# Lower Thames Crossing

## 9.190 Post-event submissions, including written submission of oral comments, for ISH13

Planning Inspectorate Scheme Ref: TR010032  
Examination Document Ref: TR010032/EXAM/9.190

Plate A.2.1 Applicant v3.6 DM model

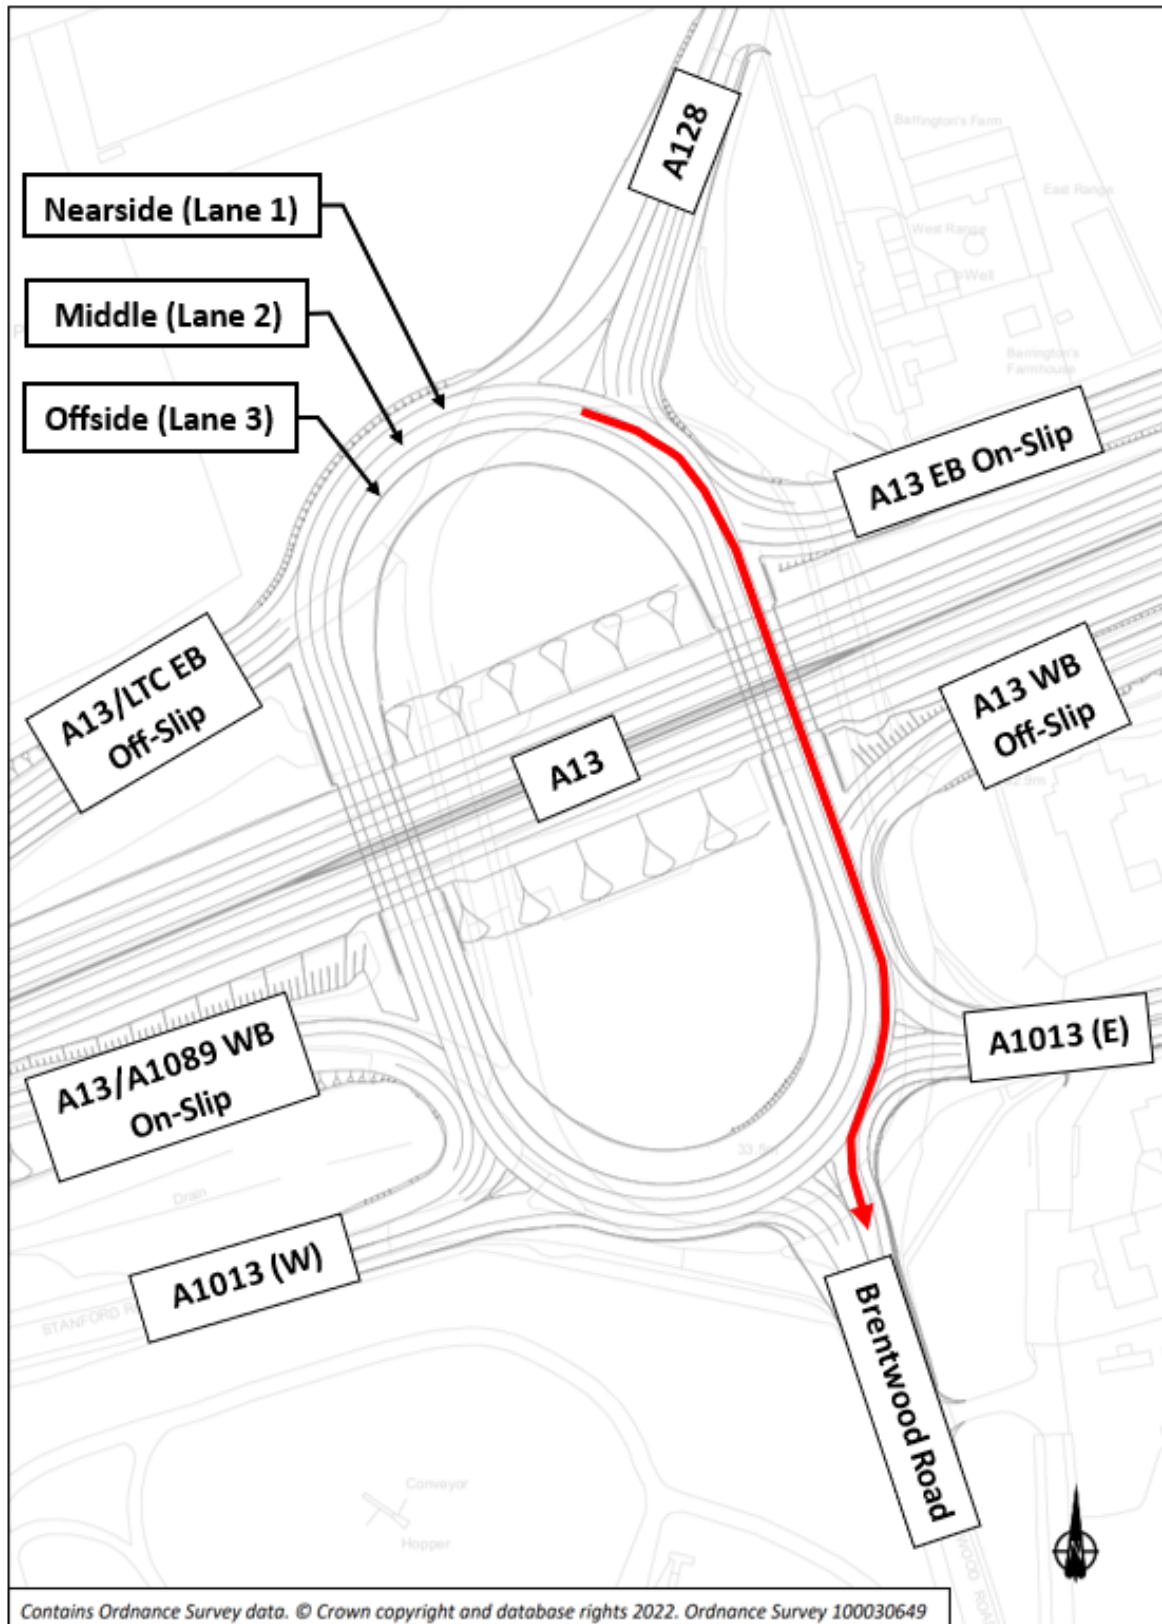
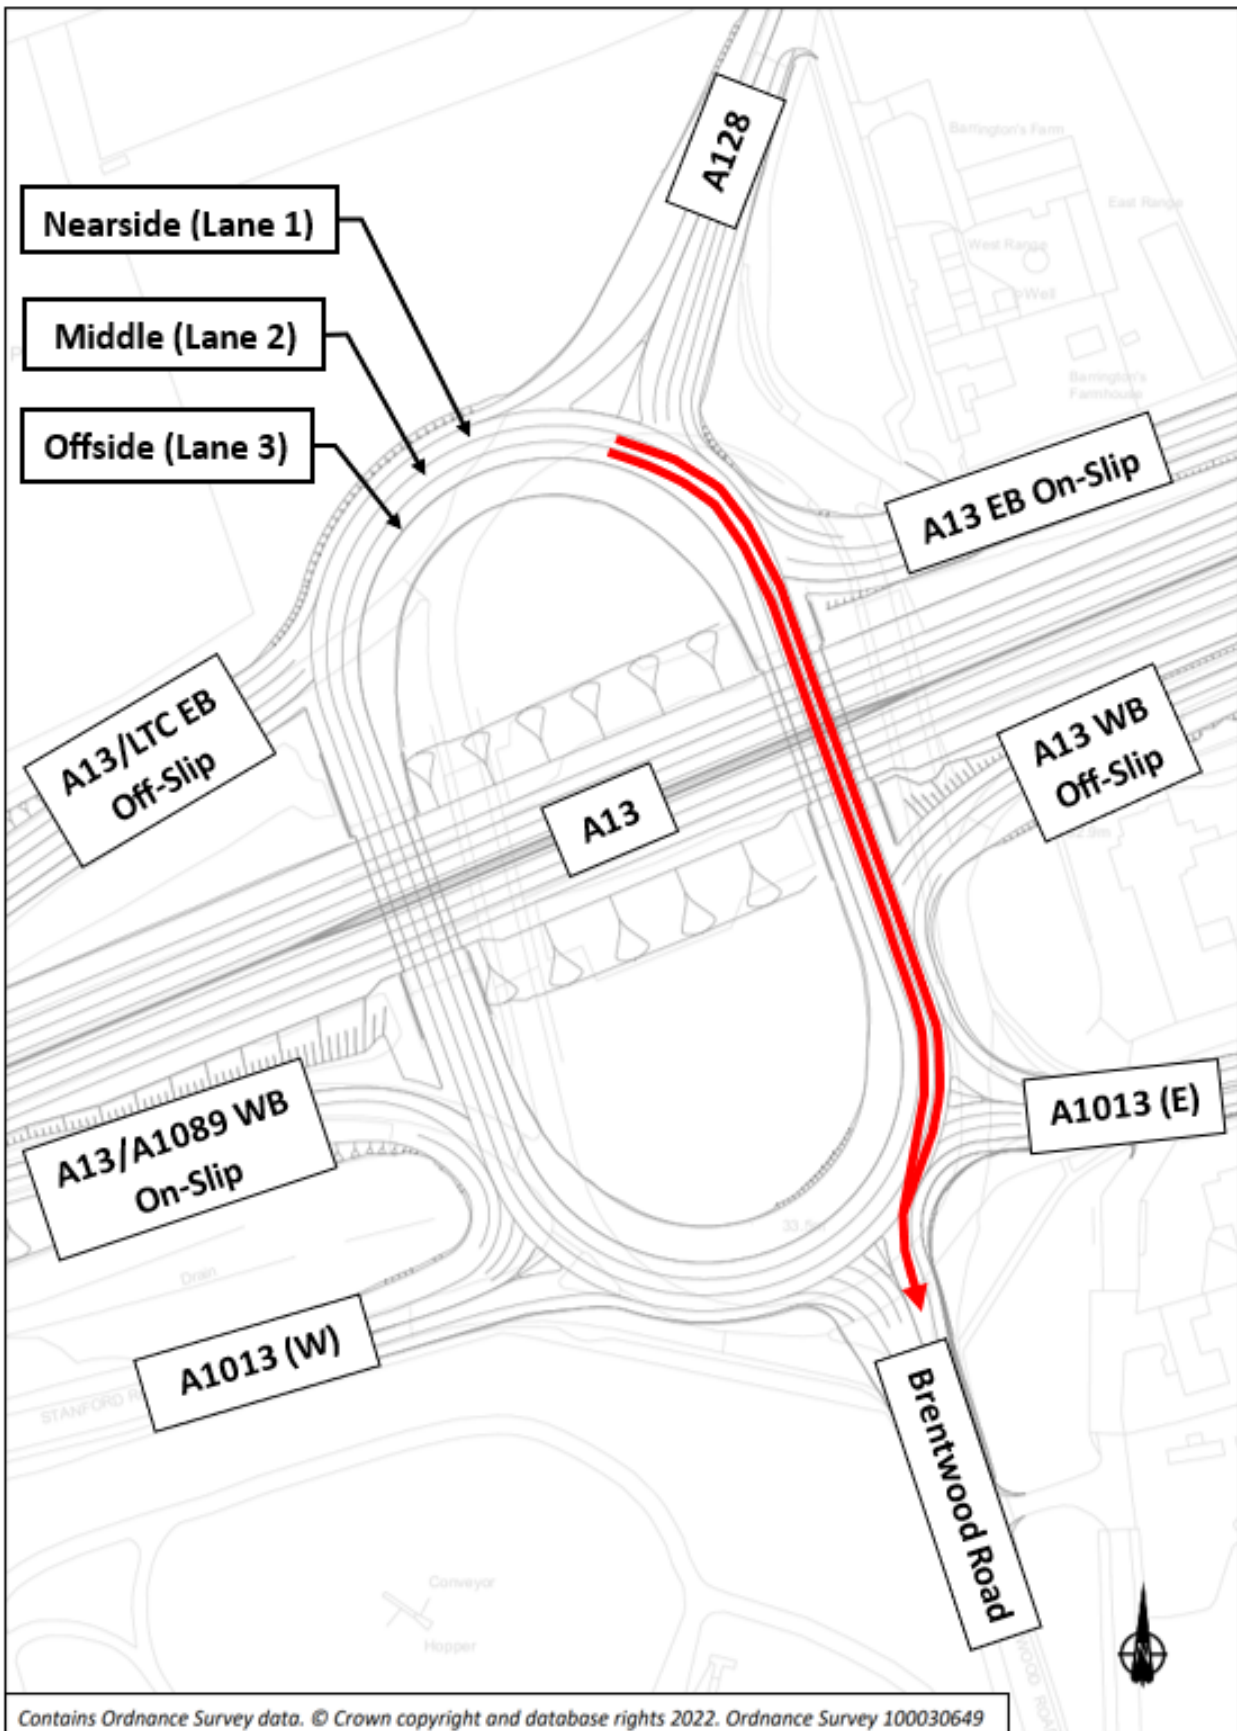
- A.4.3 Following Thurrock Council's audit of the v1 DM model and within their Deadline 3 submission, Appendix E, Annex 5, Item 3 [\[REP3-207\]](#) Thurrock Council requested that the Applicant's DM model be amended for traffic to Brentwood Road to only use the nearside lane, as shown in Plate A.2.1 of Appendix A.2 to this Annex. The Applicant made this change to the DM model in v3 (v3.6) in October 2023.

### Plate A.2.3 Applicant v3.6 DS model

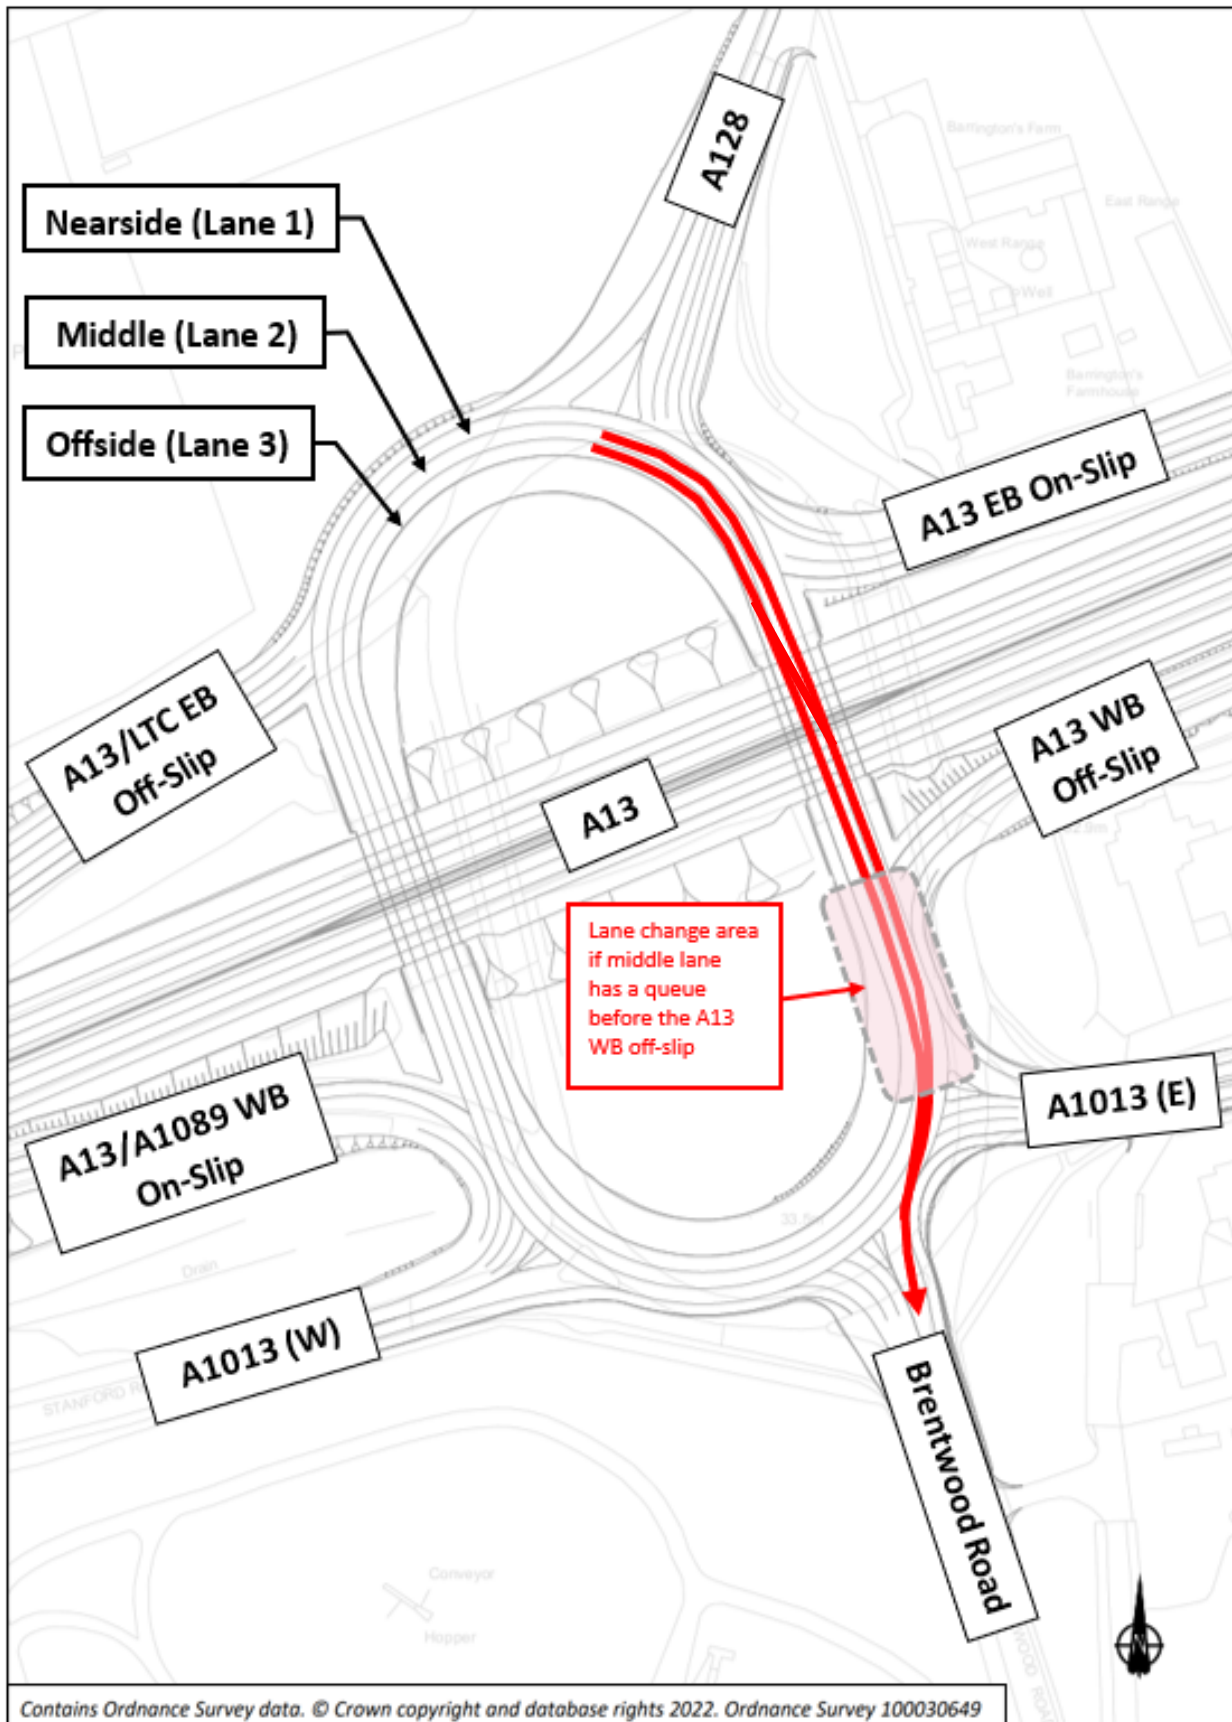
- A.4.5 In the Applicant's v3.6 DS model, which include the introduction of traffic signals at the A128 and Brentwood Road approaches, the Applicant coded the lane designation for traffic to Brentwood Road to use the middle lane and the offside lanes. It should be noted that if traffic to Brentwood Road in the offside lane cannot change lane before the A13 WB off-slip traffic signals because of queuing traffic in the middle lane, the lane change (for traffic in the offside lane to the middle lane) happens in the space after crossing the stop line at the A13 WB off-slip and the A1013 (E) arm. This can be seen in Plate A.2.3 of Appendix A.2 to this Annex. The Applicant refutes Thurrock Council's comment that there are 3 lanes merging into a single lane at the Brentwood Road exit and that any merging of traffic occurs at the location the Council is showing in their Deadline 6A submission (Submission of comments by Local Highway Authorities, Ports and other IPs engaged in traffic and transportation topics relating to traffic modelling and intended to be heard at ISH13 on 27 November 2023 [\[REP6A-013\]](#)) in paragraph 3.1.16 in Figure 3.3. This can be seen in Plate A.2.3 of Appendix A.2 to this Annex.

Plate A.2.4 Thurrock Council v3.6T DS model

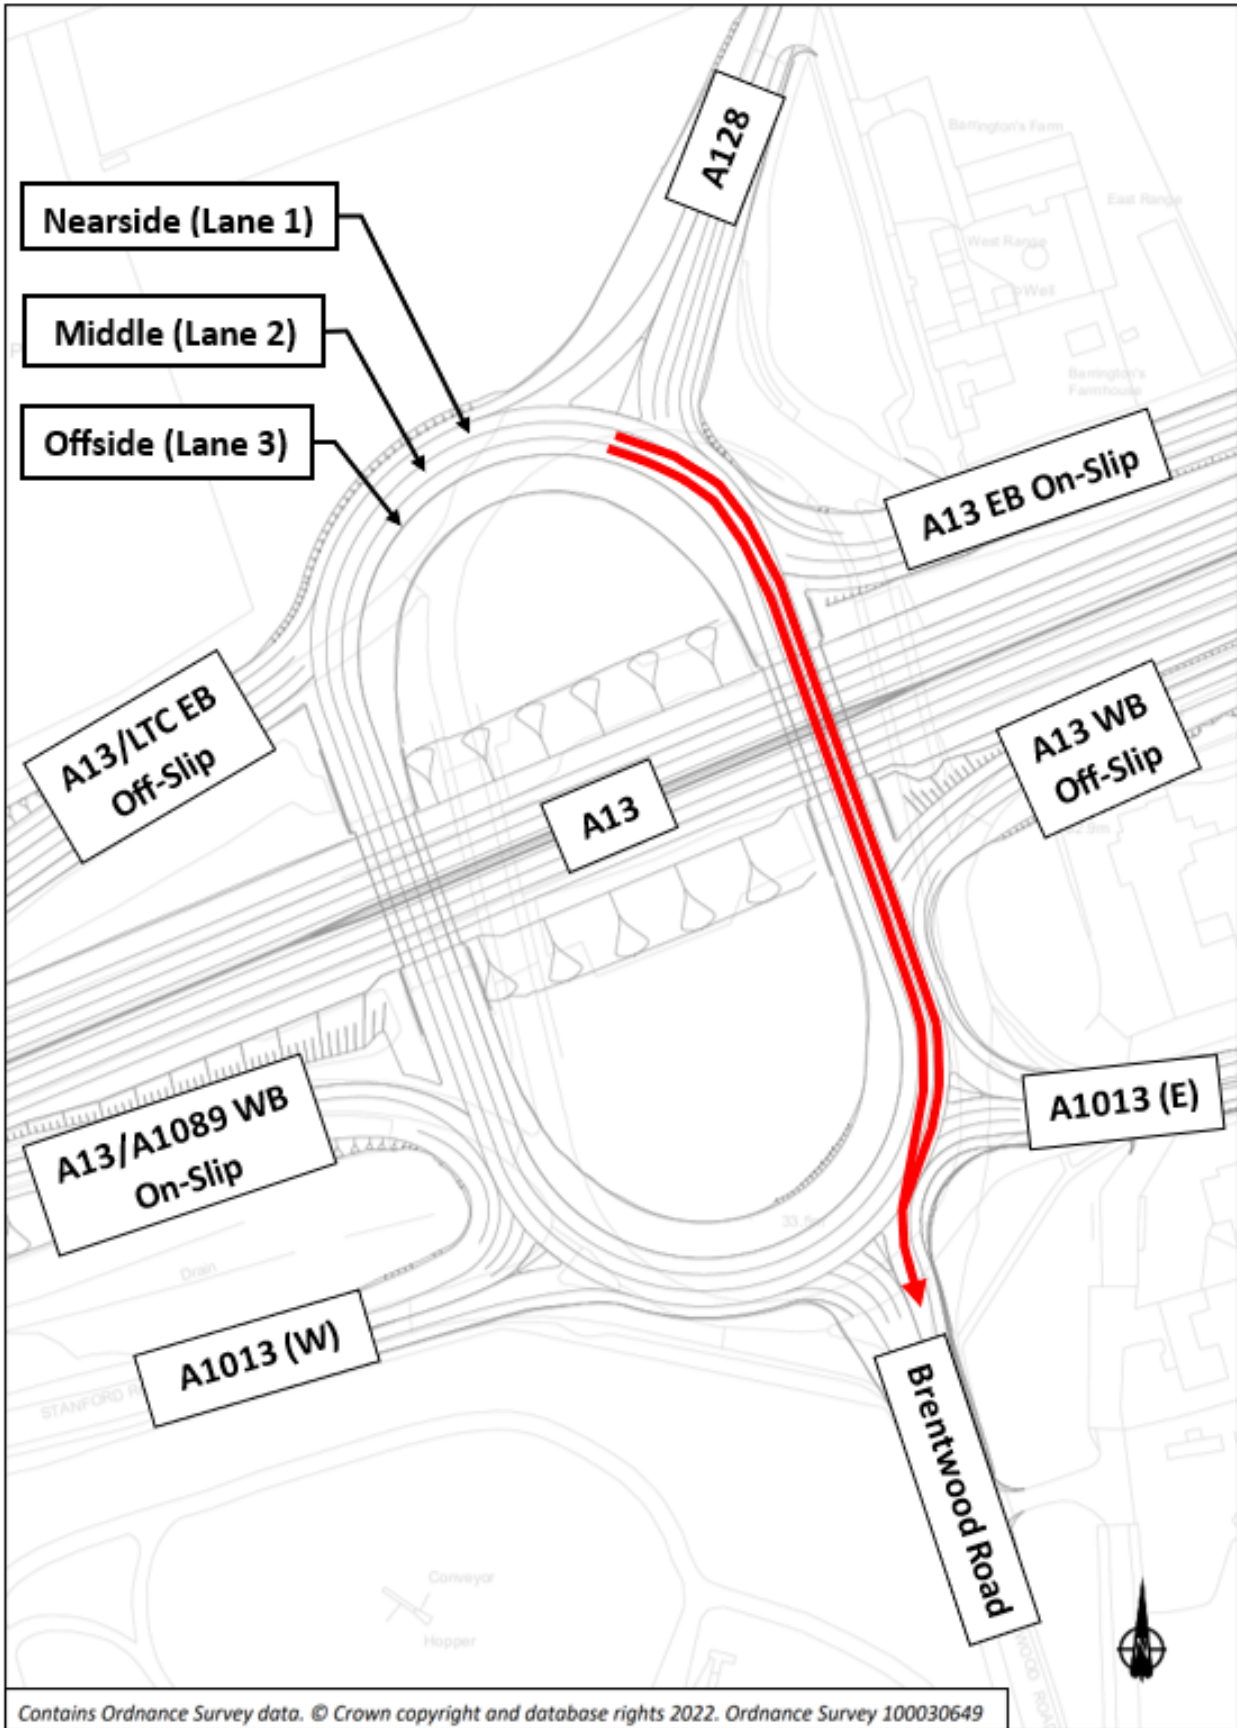
- A.5.10 The Council's v3.6T DS modelling uses the nearside lane and middle lane on the southbound circulatory to Brentwood Road. Given there is also a large volume of traffic traveling to A1013 (E) that can only use the nearside lane, the majority of traffic to Brentwood Road is forced to use the middle lane only before the traffic signals by the A13 WB off-slip. More vehicles on the offside lane will have to stop and wait before the stop line to change into the middle lane, thus greatly reducing the throughput of that stop line. This is shown in Plate A.2.4 of Appendix A.2 to this Annex.

- A.5.11 The Applicant therefore refutes the lane allocation change for the reasons set out above.

### Plate A.2.5 Lane change restriction in Thurrock Council v3.6T DS model

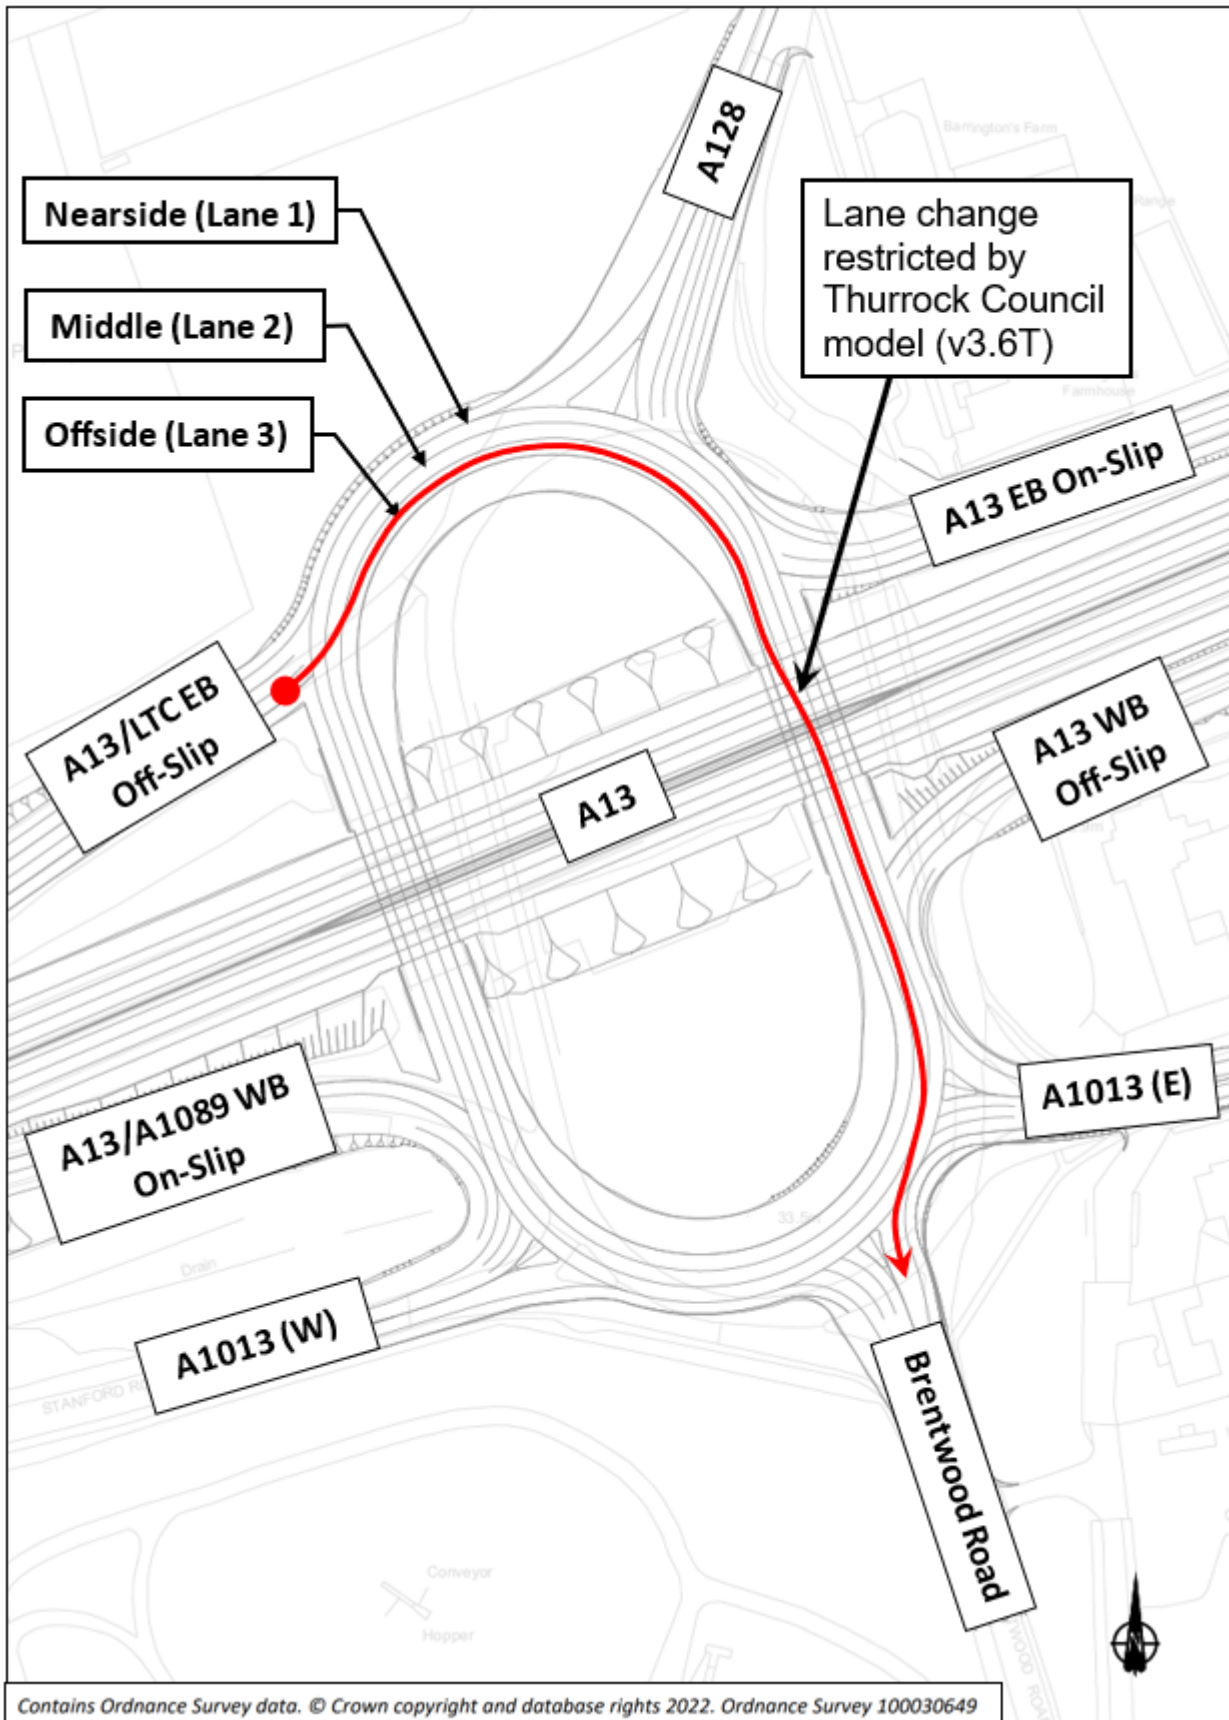
- A.5.13 The lane change distance of 150m applied in the Council's v3.6T model with the 'Applies per lane change' function activated means most vehicles to Brentwood Road change to the middle lane before the traffic signals on the northern circulatory by the A128. This puts more traffic queueing in the middle lane and causes traffic blocking back to the A13/A122 EB off-slip and northbound overbridge.

- A.5.14 The Applicant therefore disagrees with the Council's change of the lane change distance from 100m to 150m on the exit to Brentwood Road.
